Our ref: 331201108pbond002.Docx

Re: Proposed extraction of sand and gravel at Hamble Airfield: further response to consultee queries

Figure 1 Superficial deposit hydrographs – depth below ground level

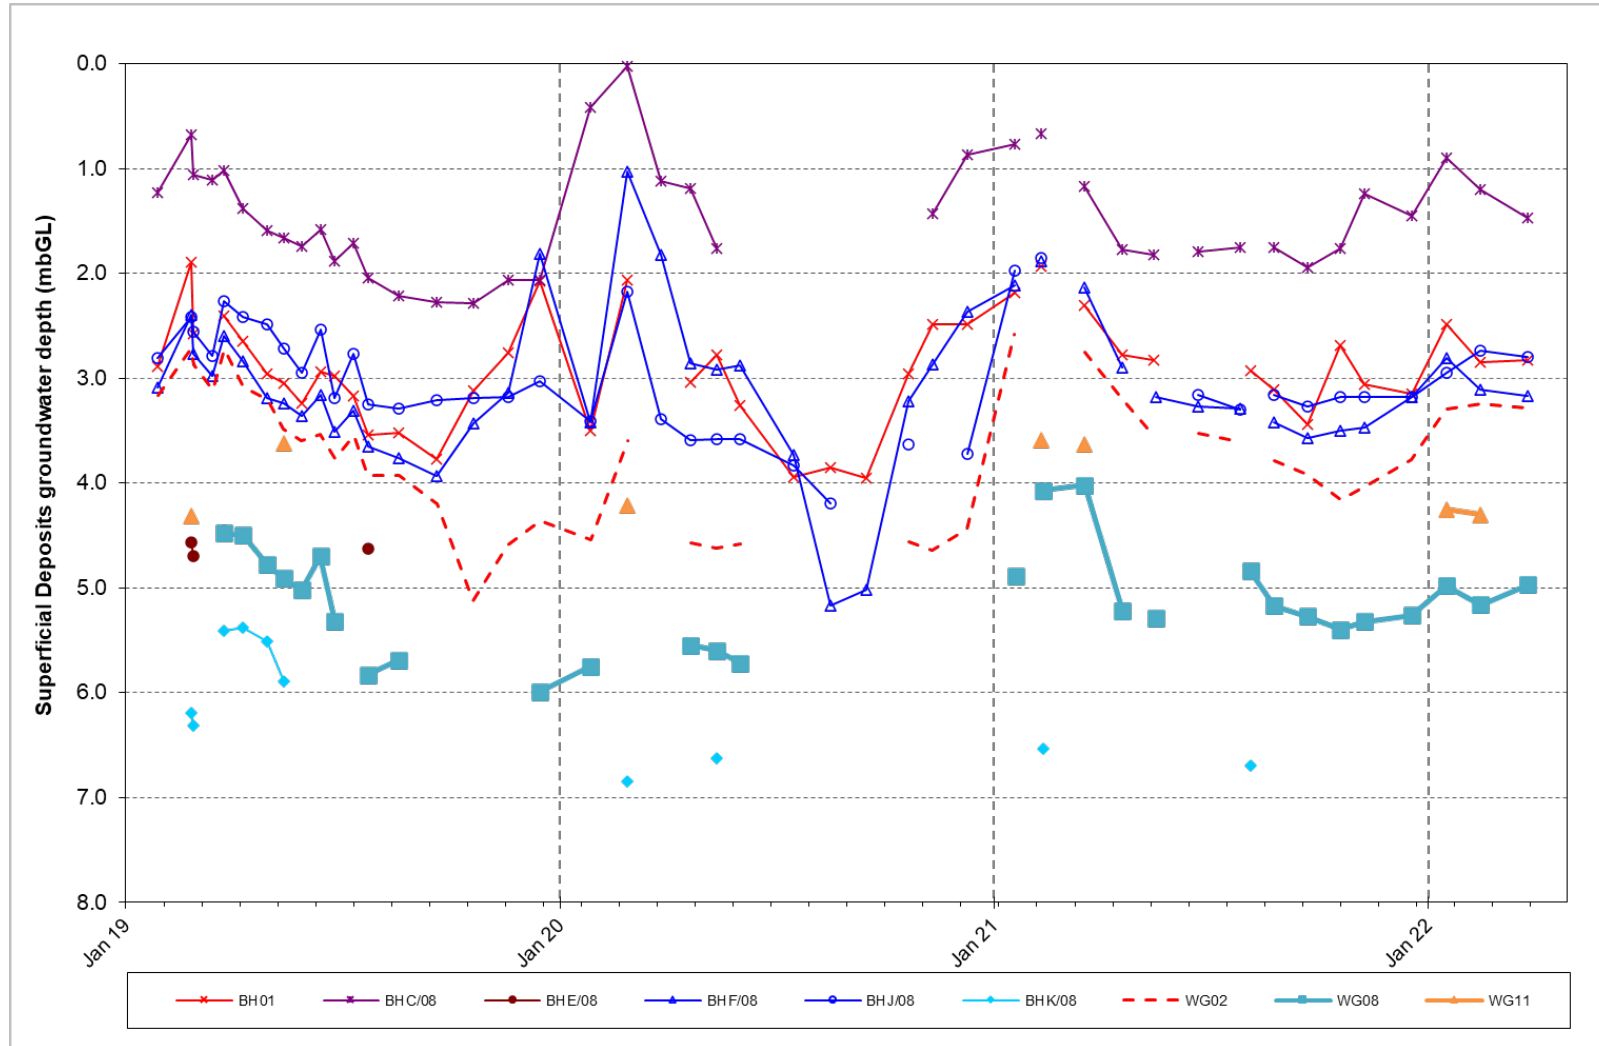
Network Rail has raised a holding objection, based on concerns regarding the effects of localised dewatering adjacent to the railway line and due to impediment of groundwater flow following restoration with imported lower permeability inert restoration materials.

The railway line runs along the northern edge of the Site, adjacent to Phase 1, which will be the first Phase to be excavated at the site. Figure 1 shows the depth to groundwater in the superficial deposits at the groundwater monitoring wells at the Site (see Figure 8.14 in Chapter 8 of the Environmental Statement for well locations). BH01, WG02 and BHC/08 monitor groundwater along the northern edge of the Site.

For the worst-case scenario, groundwater level may be reduced by about 1 and 4 m in the area of the workings. Based on the assumed aquifer properties, the radius of drawdown is assessed to be about 300 m. On this basis, the maximum drawdown below the railway is estimated to be between 1.5 and 2.5 m. The associated increase in effective stress below the railway would be between 15 and 25 kPa. Given the relatively low compressibility of the sand and gravel and the underlying solid geology, any resulting settlement of the railway is expected to be less than 10 mm. The associated differential settlements are governed by the gradient of the drawdown curve and are expected to be less than 1 mm in 10 m.

We note that there is little groundwater present within the superficial deposits to the south of Phase 1 of the proposed quarry, particularly on the western and southern sides. The gaps in the hydrographs for the wells to the south of Phase 1 shown on Figure 1 mostly represent occasions when the wells are dry. To illustrate this further, we have enclosed plots showing the dip to water and plumbed base of each of the wells that are monitoring the sand and gravel deposits, which show the limited saturated thickness and periods when wells are dry within the sand and gravel deposit.

BHE/08

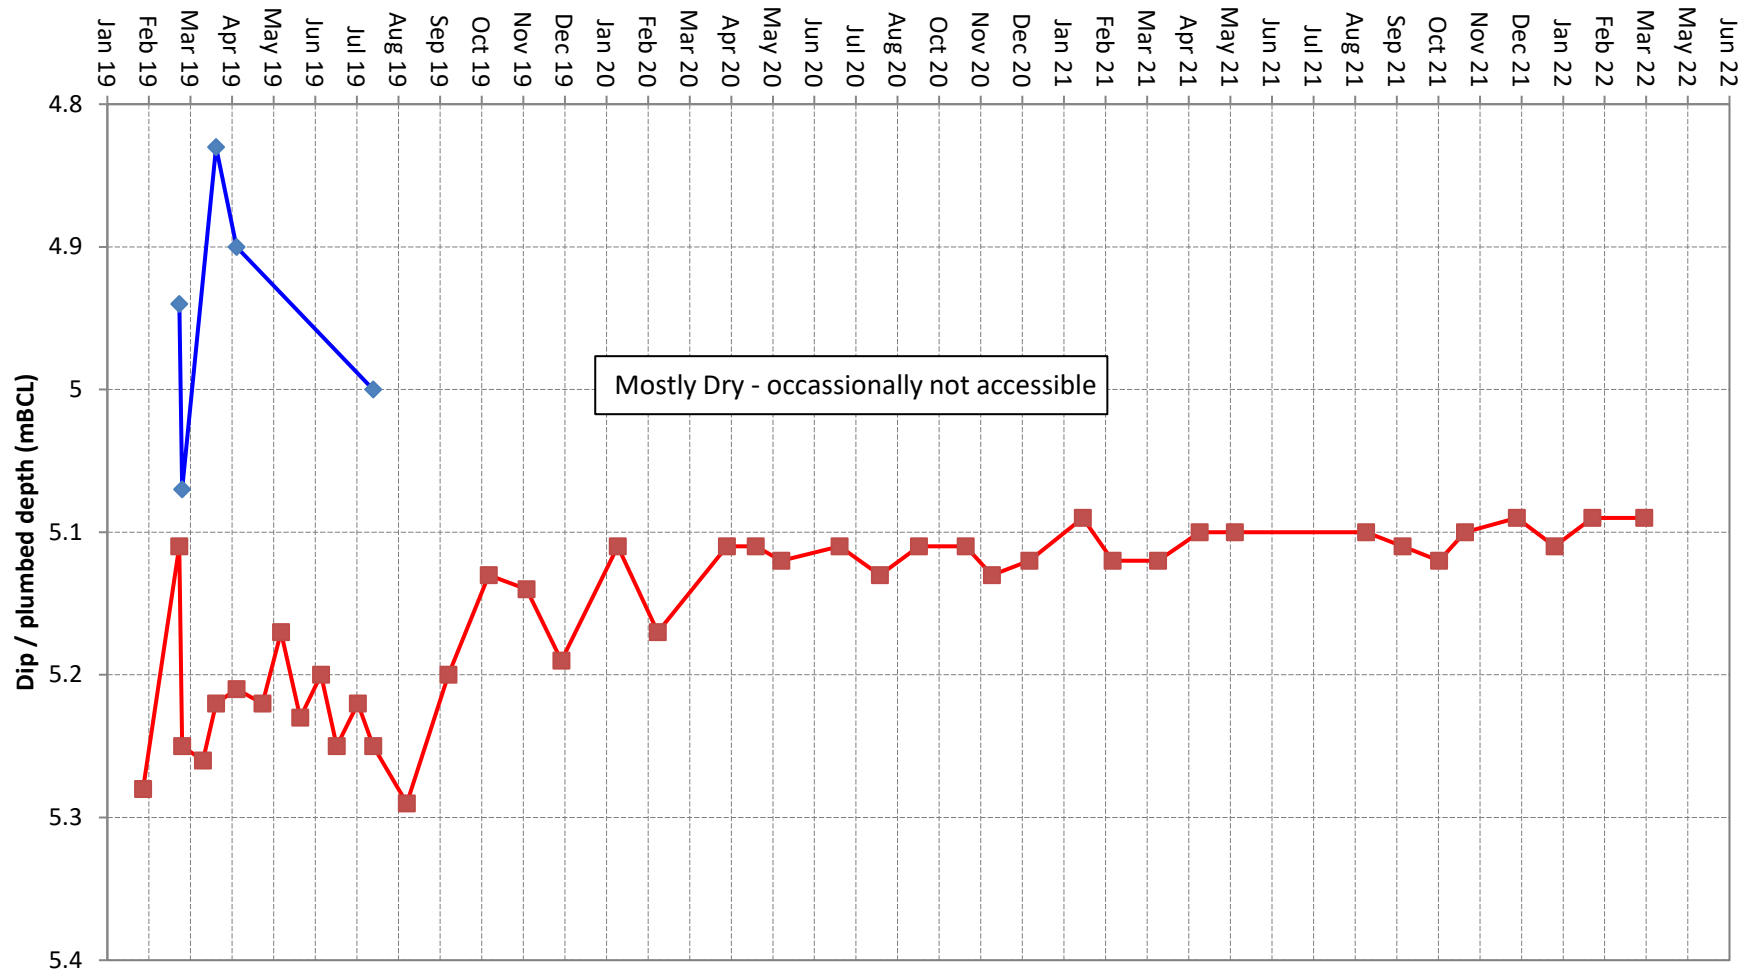
We note that the chances of detecting such contamination, via site investigation, would be very small. One of the reasons for the Environment Agency making the comments on contamination was the possible presence of trace hydrocarbon recorded at BHE/08 between 4.5 and 4.8 m below ground level, which was described as a 'Black dry residue on gravel. No oil sheen on water'. We note that two boreholes have subsequently been drilled close to BHE/08; BH05 in May 2011 and W05 in November 2018. Neither of these boreholes recorded any black residue on the gravel, suggesting that its presence is extremely localised. W05 did not strike any groundwater, whilst BHE08 struck water at 4.72 mbGL (0.58 m above the base of the sand and gravel deposit) which rose to a steady level of 2.40 m. However, the groundwater level has been monitored at BHE/08 from 2012 to the

current time and is usually recorded as dry. (W05 is installed and monitors groundwater in the Selsea Sand Formation below the sand and gravel deposit).

Thus, we consider that the risk posed by mobilising low solubility in-situ contamination, largely present above the watertable, to be negligible and the likelihood of detecting any significant quantities of such contamination too low to justify further site investigation.
